From: Mike Gaither
To: [Saxton, John](#)
Cc: [Burrows, Ronald](#)
Subject: [External_Sender] RE: Three Revised Figures for the Met report
Date: Monday, December 11, 2017 1:40:13 PM
Attachments: [LC Wind Roses POR rev.pdf](#)

From: Saxton, John [mailto:John.Saxton@nrc.gov]
Sent: Monday, December 11, 2017 10:22 AM
To: Mike Gaither <mike.gaither@UR-Energy.com>
Cc: Burrows, Ronald <Ronald.Burrows@nrc.gov>
Subject: Three Revised Figures for the Met report

Please revise and resubmit the following three (3) wind roses from the November 11, 2017 report.

2013

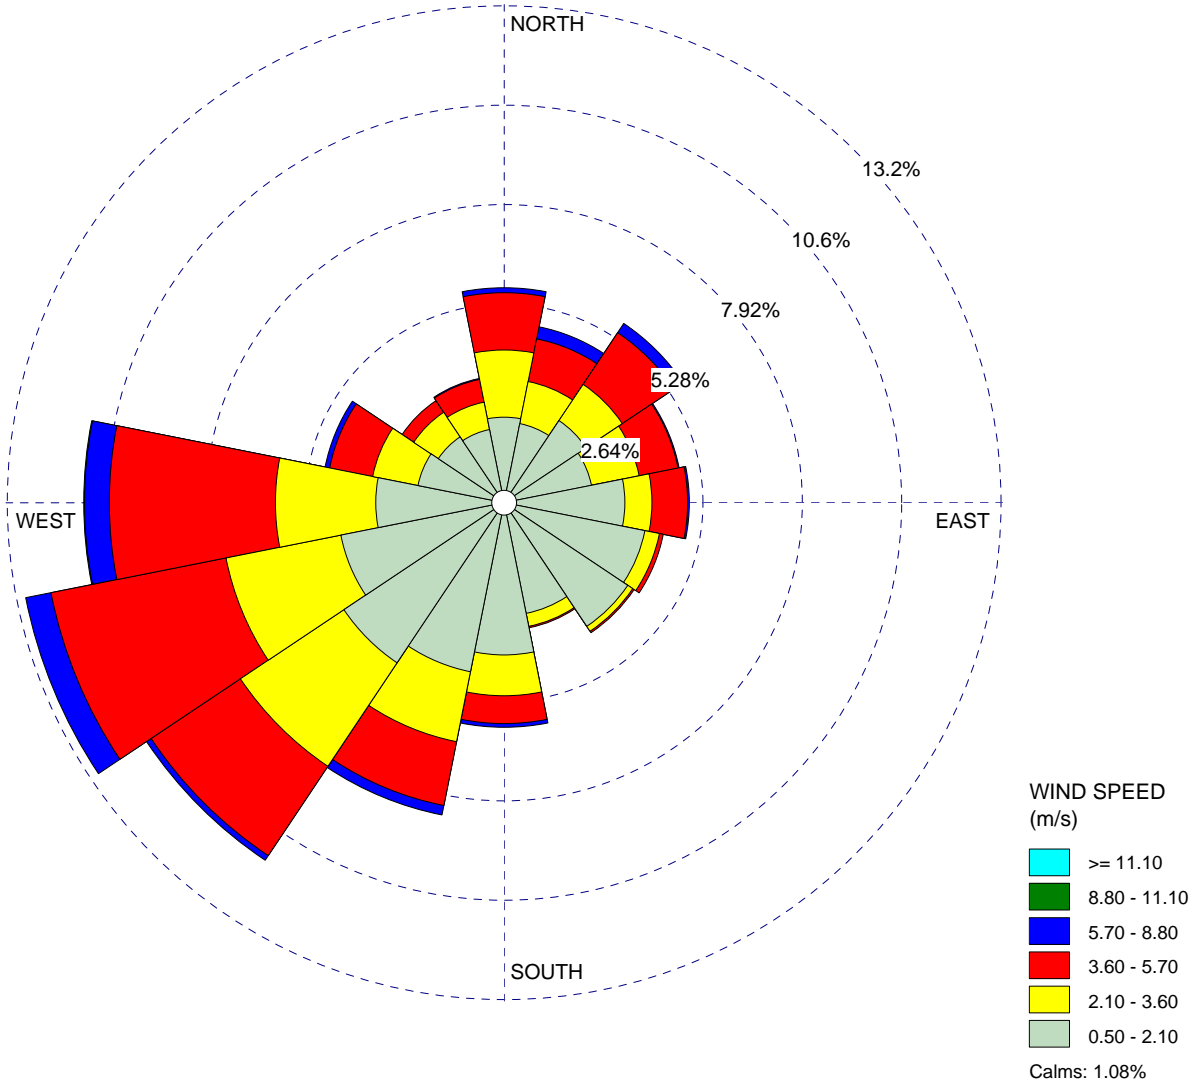
- (1) 2013 - The data period suggests it was 2014 instead of 2013
- (2) 2014 - The data period suggests it was 2013 instead of 2014
- (3) Composite for period of Record (2009-2010, 2012-2014) – The data period suggest that data collected at less than the minimum recovery rate (e.g., 2011, 2015) were included in the wind rose

Here is the full pdf that includes the corrected roses and correct distribution table for POR. Let me know if you need anything else.
